SOUTHWEST BIKEPATH CULVERT REPLACEMENT AT WAITE CIRCLE - 2019

CITY OF MADISON, WI

CITY PROJECT NO. 8466

ADDENDUM 1
8/29/19
CHANGED ENTIRE
DRAWING

**CIVIL
CLEARING,
GRUBBING AND
TREE REMOVAL
PLAN**

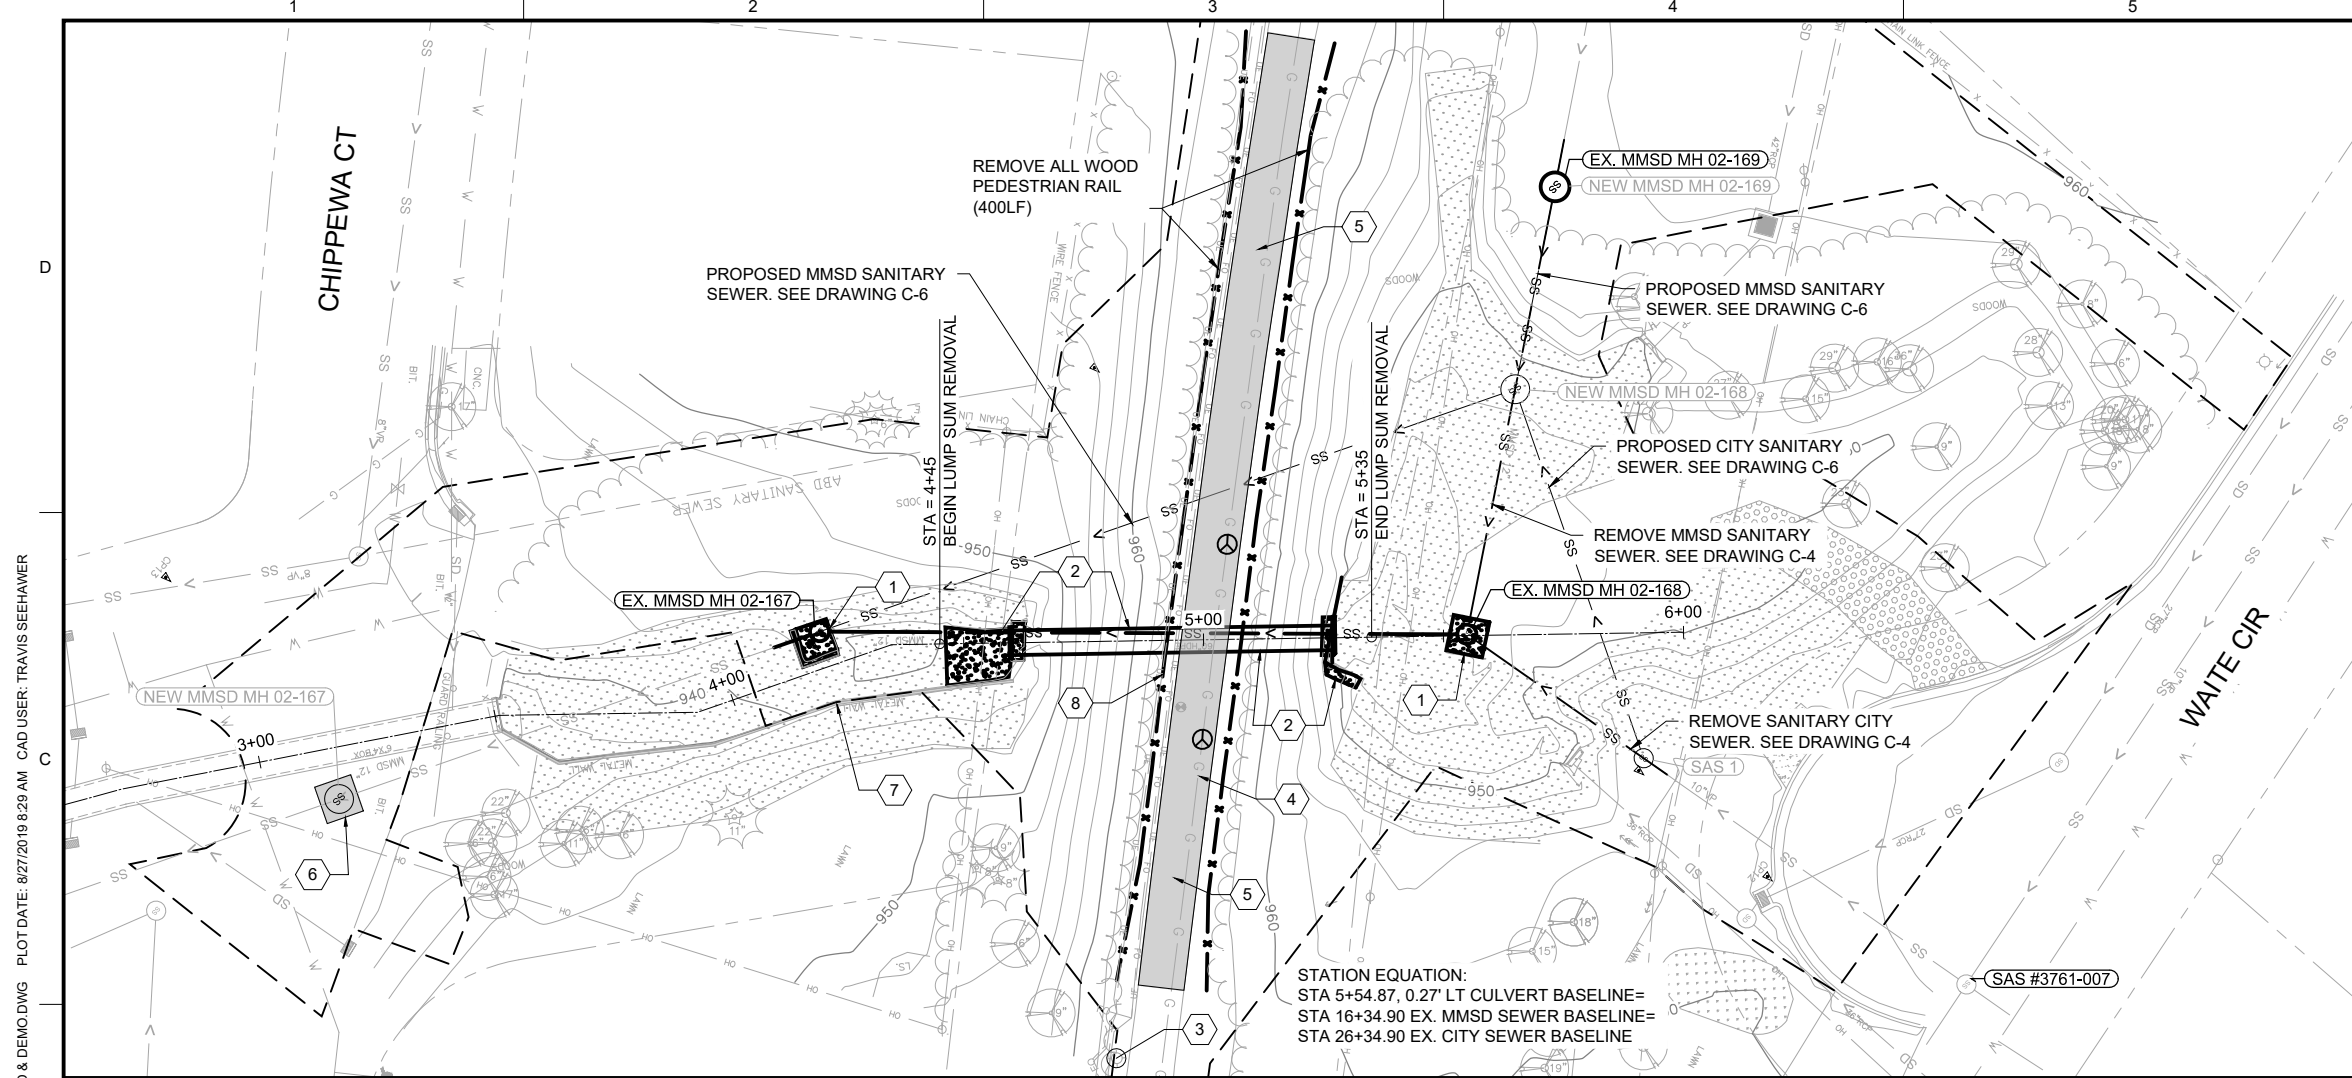
**ADDENDUM 1
CHANGED
ENTIRE
DRAWING**

**CIVIL
REMOVAL PLAN &
PROFILE - BOX
CULVERT &
SANITARY SEWER**

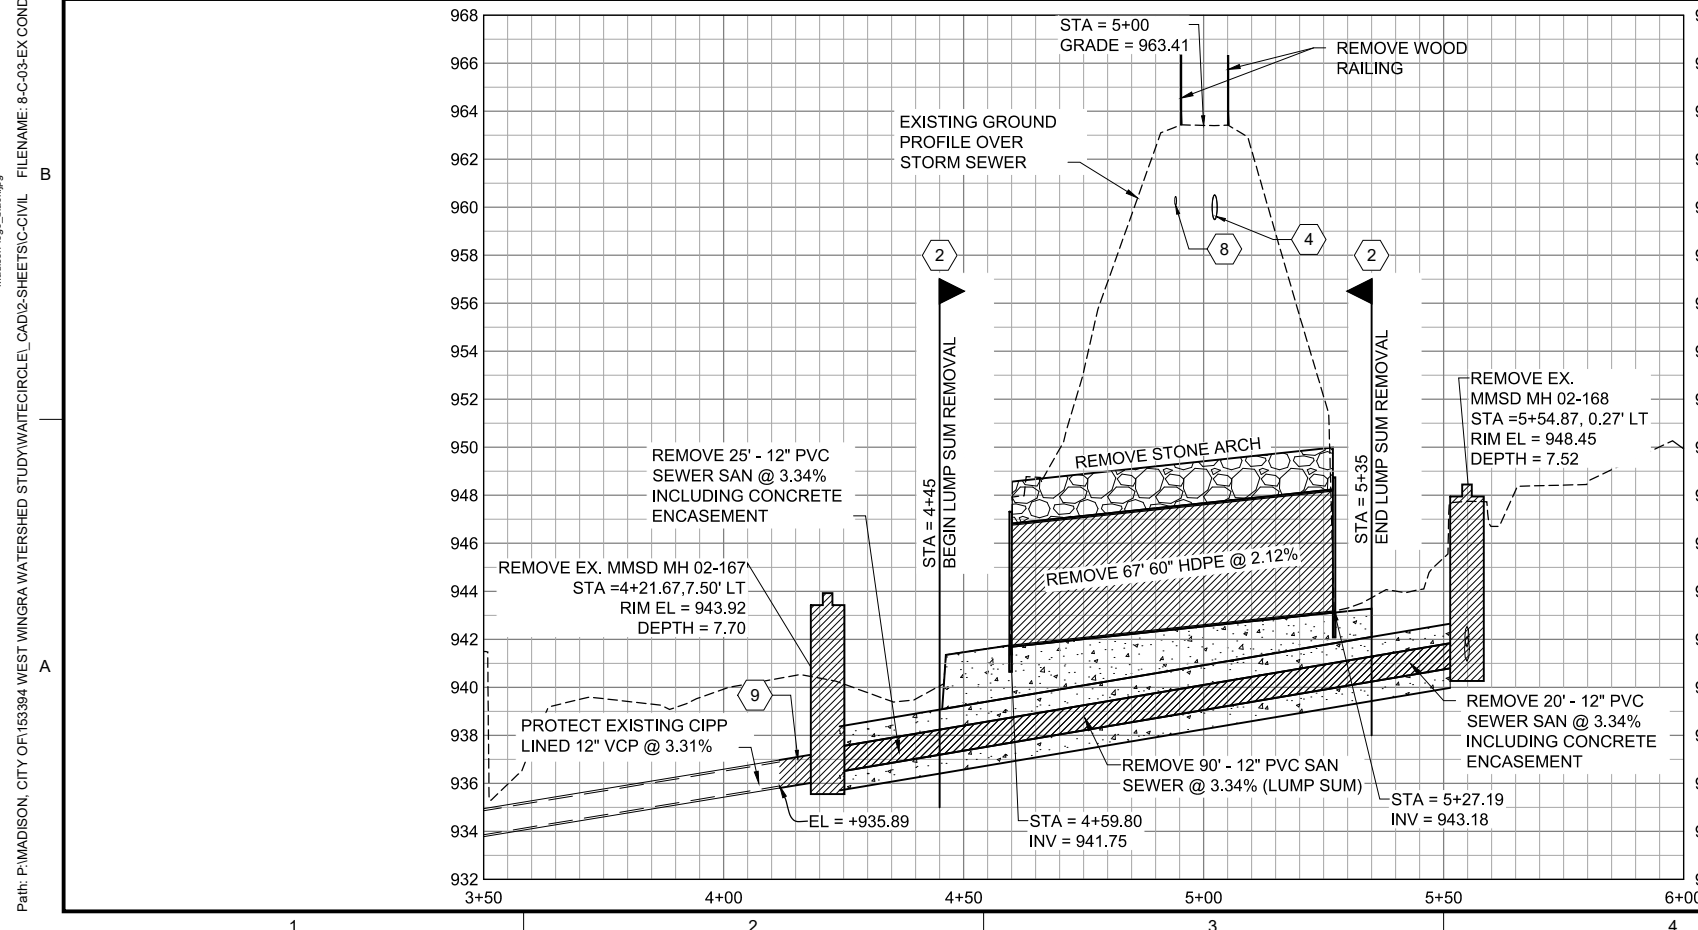
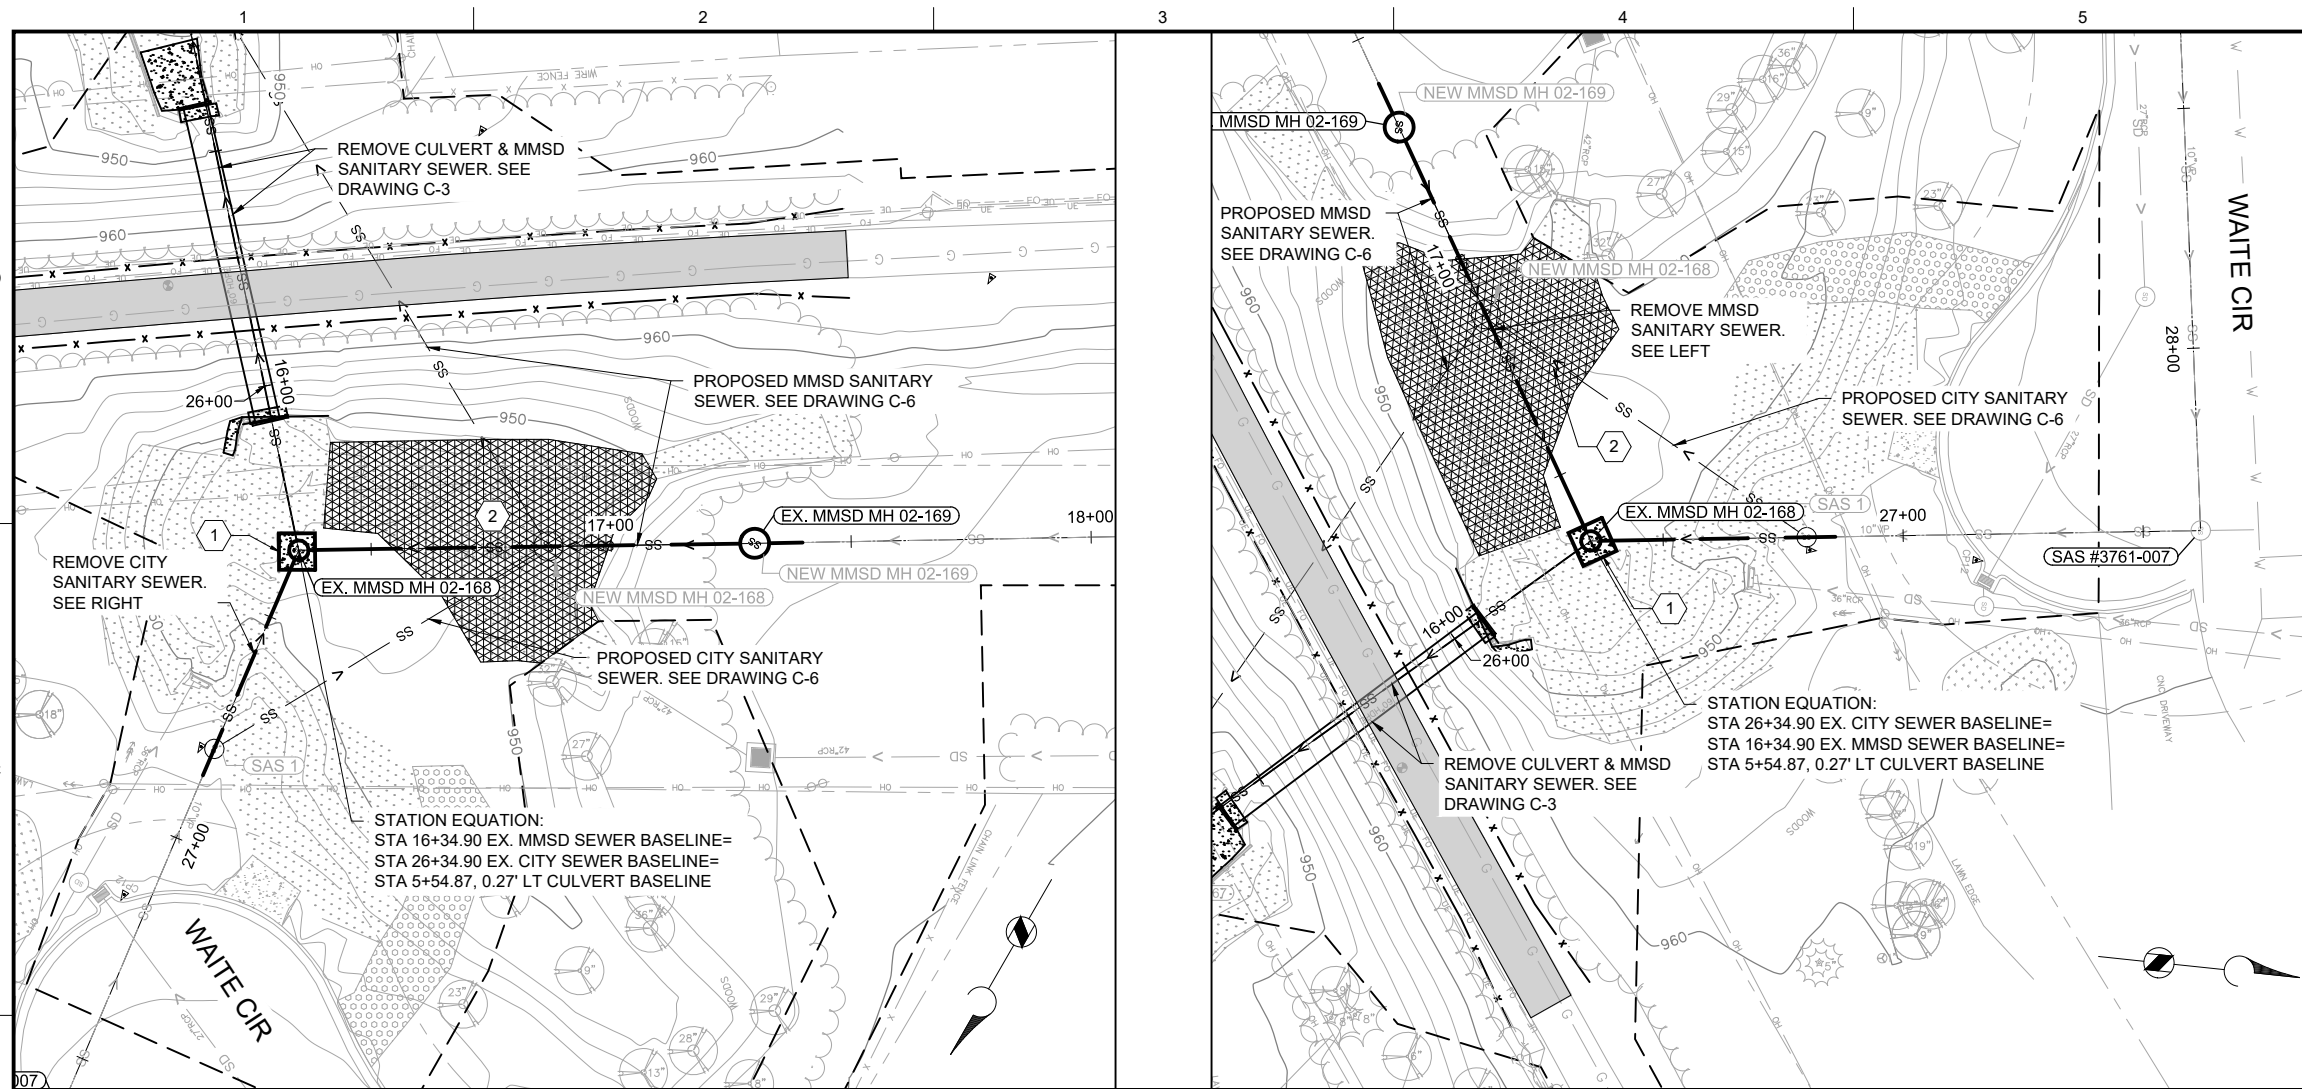
**ADDENDUM 1
CHANGED
ENTIRE
DRAWING**

**CIVIL
REMOVAL PLAN &
PROFILE -
SANITARY SEWER**

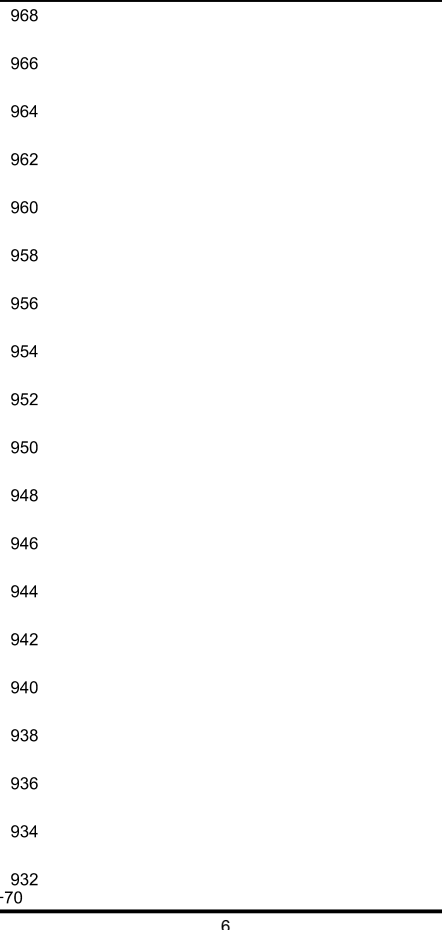
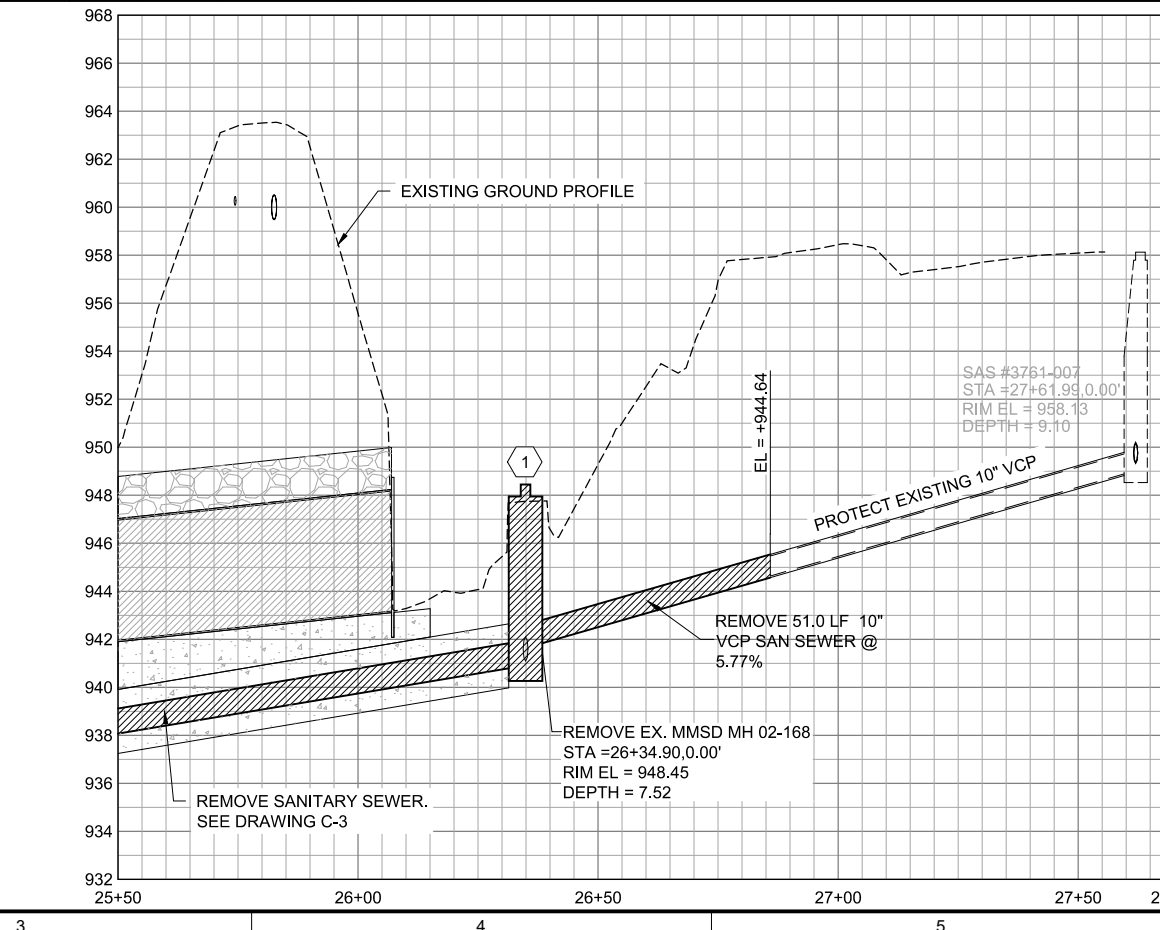
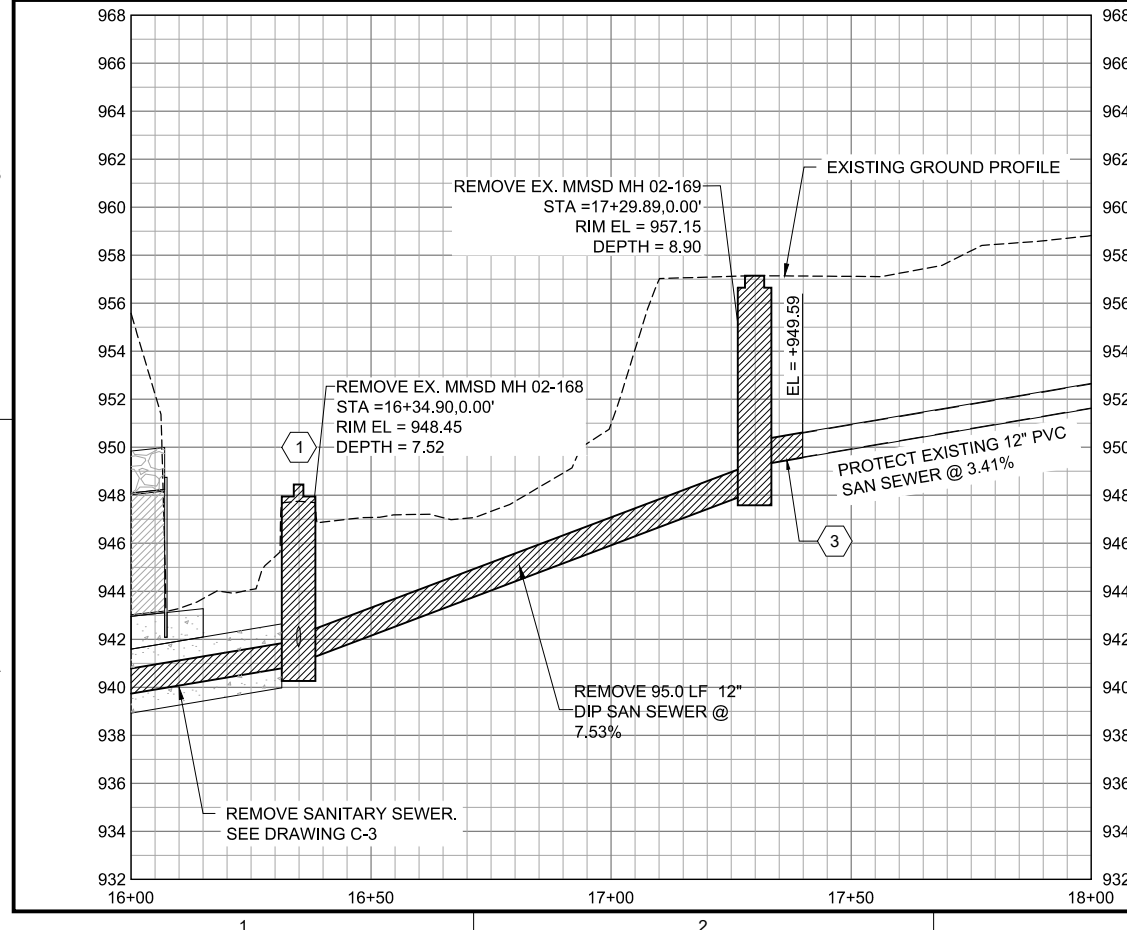
**ADDENDUM 1
CHANGED
ENTIRE
DRAWING**
